Bryant Development and Review Committee Meeting

3. Hillcrest Addition Subdivision - 3927 Springhill Road

Tim Lemons - Requesting Recommendation for Preliminary Plat Approval

Please accept this letter in response to your latest comments as provided in an email on October 22, 2024. I will address the items in the order expressed (my response is shown in ***bold italicized***):

⑥ - DRAINAGE STRUCTURE #

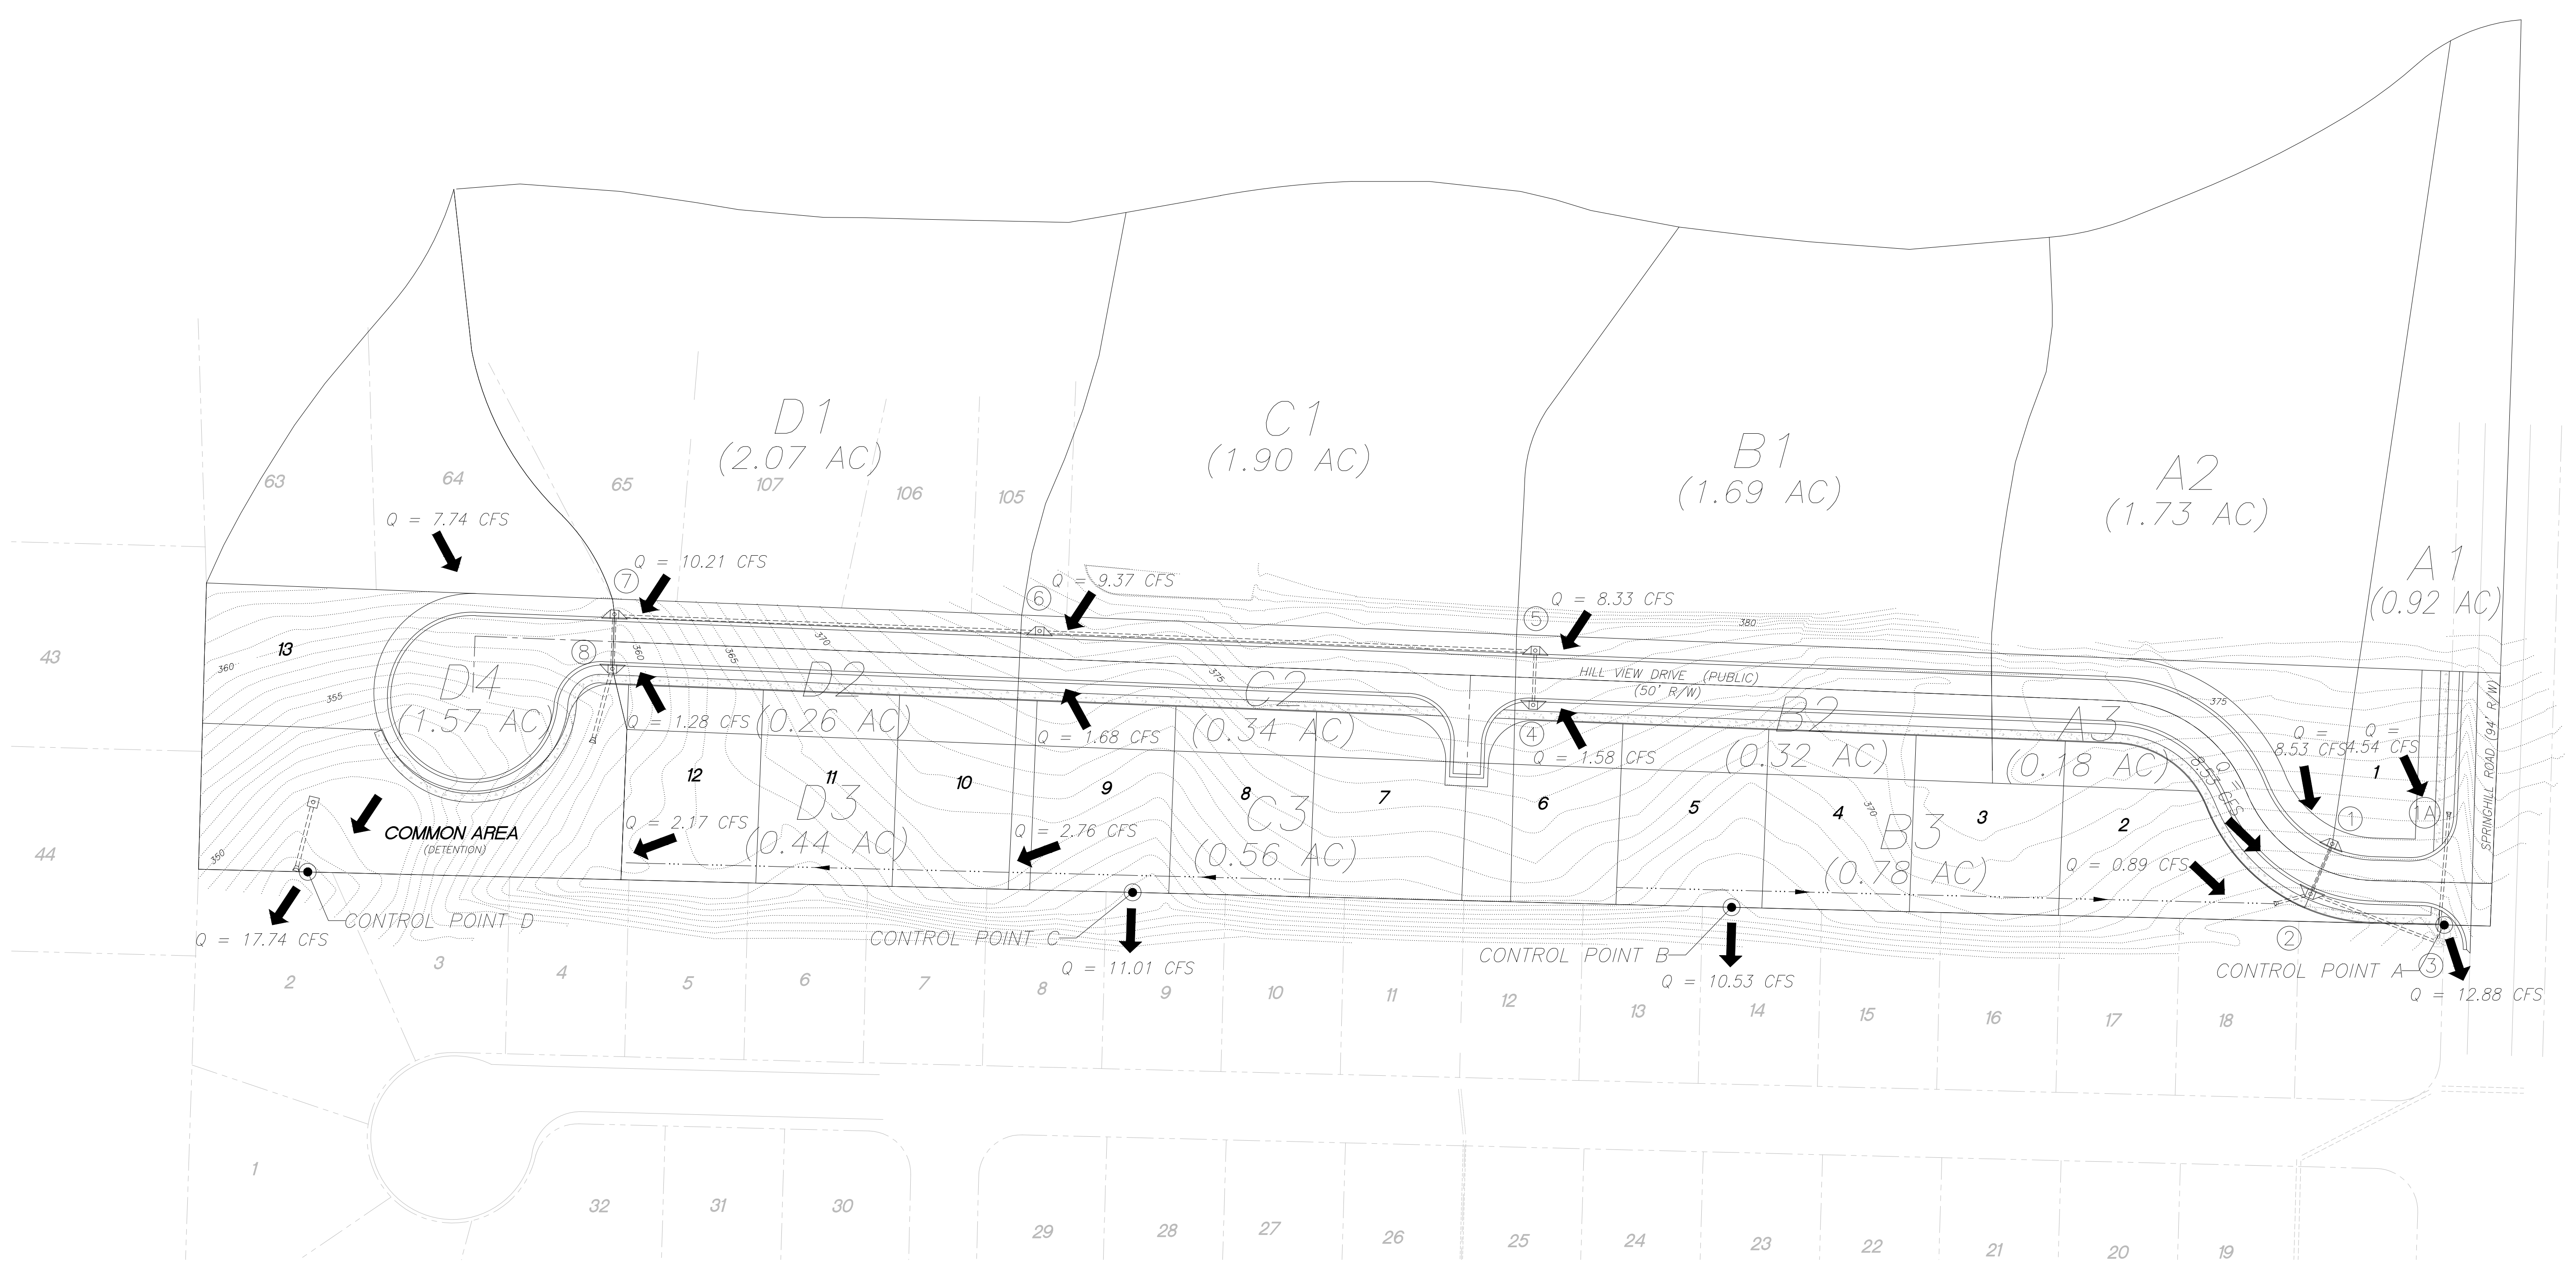
1. The post-construction map shows the discharge from Control Point A as being 12.88 cfs. Page 34 in the calculations shows it as being 16.81 cfs. ***This has been corrected. See attached revised map.***
2. The post-construction map shows discharge from Control Point B and C and there is no discharge shown in the calculations. ***This has been corrected. See attached revised map.***
3. The post-construction map shows discharge from Control Point D as being 17.74 cfs but the calculations on page 34 show 38.08 cfs with no detention and 16.45 cfs with detention. ***This has been corrected. See attached revised map.***
